Alton Coal Development, LLC

Re: Housekeeping Corrections and Updates/Corrections for Coal Hollow Project, Kane County, Utah, C/025/0005

Title: Mining and Reclamation Plan - Housekeeping Corrections & Updates/Corrections

Drawing 6-6
Location map for
Coal Hollow Project
cross-sections

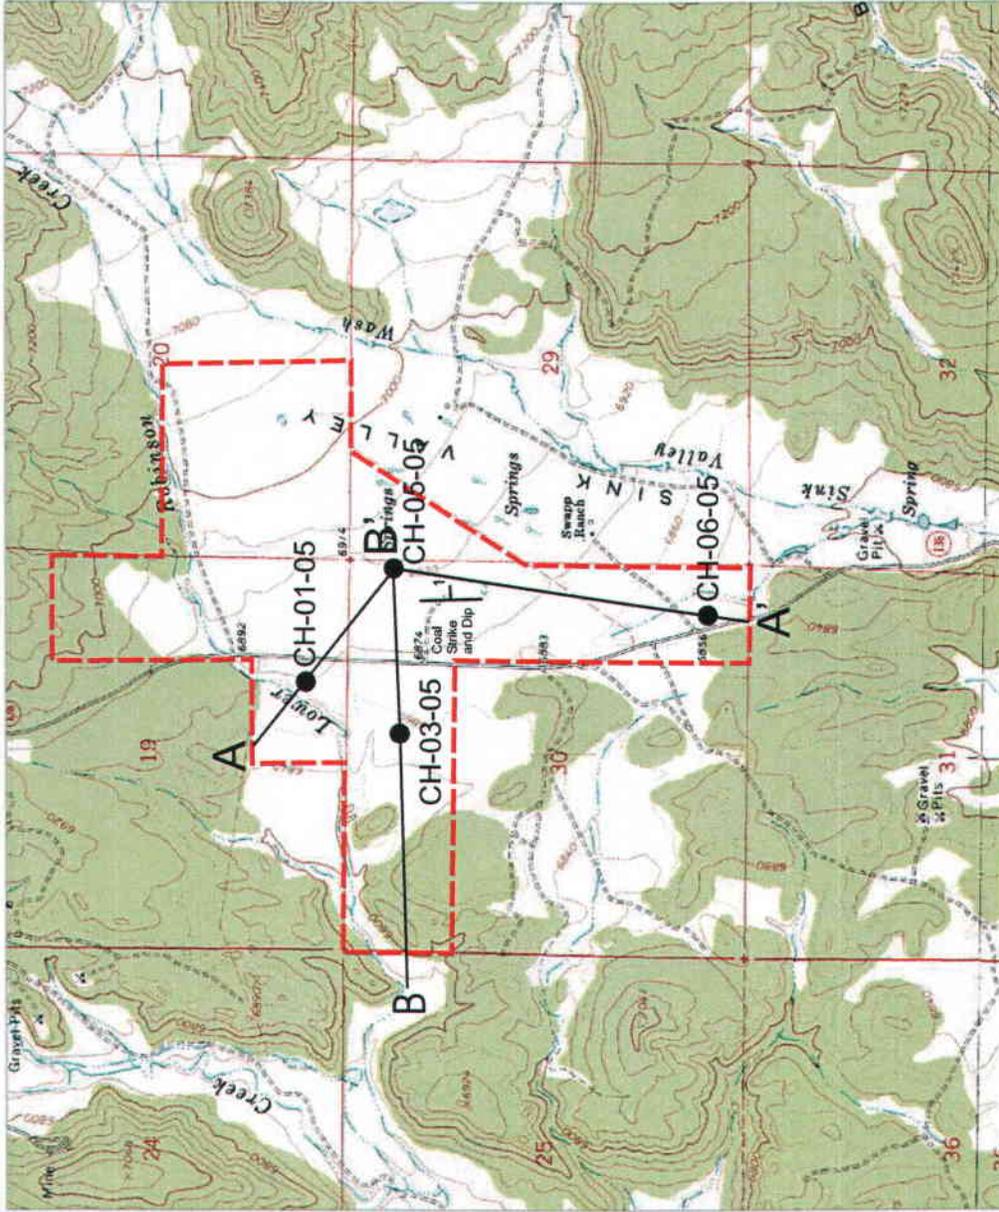
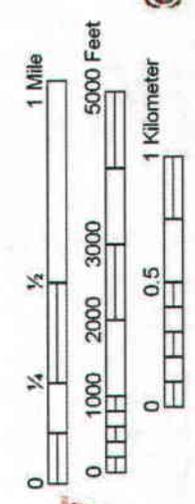
Item #1: R645 - 301- 622.300 requires strike and dip be shown on a map. Strike and dip are not evident on Drawings 6-1 and 6-6 (see statement in Section 622.300). Clearly indicate strike and dip on Drawings 6-1 and 6-6, or if strike and dip are shown on other maps, correct the reference in Section 622.300.

Drawings 6-1 and 6-2 have been edited to include a symbol showing the strike and dip of the coal seam. These drawings are resubmitted with this information added.
